TMS320F280x, TMS320C280x, TMS320F2801x DSPs Silicon revisions C, B, A, 0

1 Introduction

Figure 3. Difference Between Expected and Erroneous Operation of START Bit

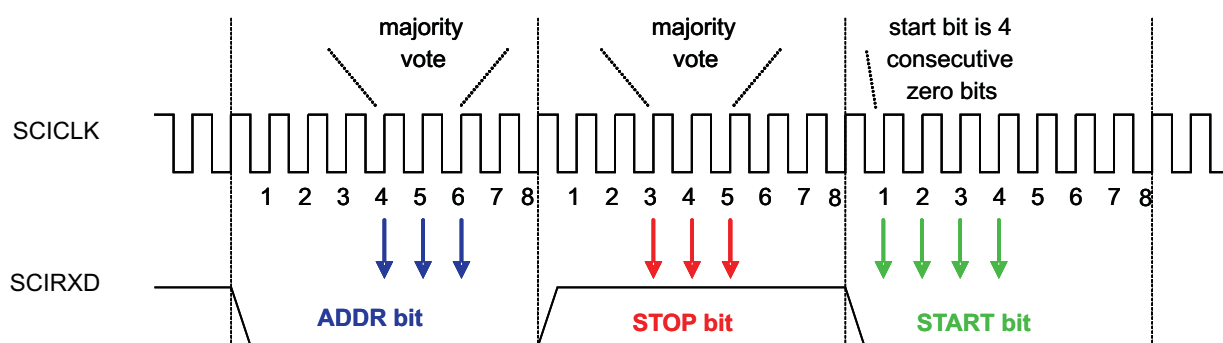
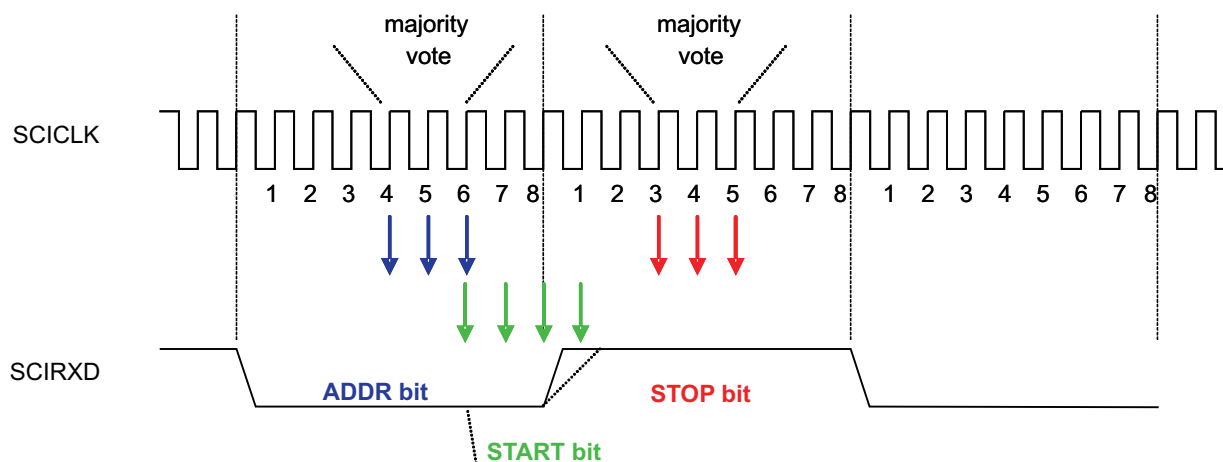
SCI: Incorrect Operation of SCI in Address Bit Mode

SCI does not look for STOP bit after the ADDR bit. Instead, SCI starts looking for the start bit beginning on sub-sample 6 of the ADDR bit. Slow rise-time from ADDR to STOP bit can cause the false START bit to occur since the 4th sub-sample for the start bit may be sensed low.

Program the baud rate of the SCI to be slightly slower than the actual. This will cause the 4th sub-sample of the false START bit to be delayed in time, and therefore occur more towards the middle of the STOP bit (away from the signal transition region). The amount of baud slowing needed depends on the rise-time of the signal in the system. Alternatively, IDLE mode of the SCI module may be used, if applicable.
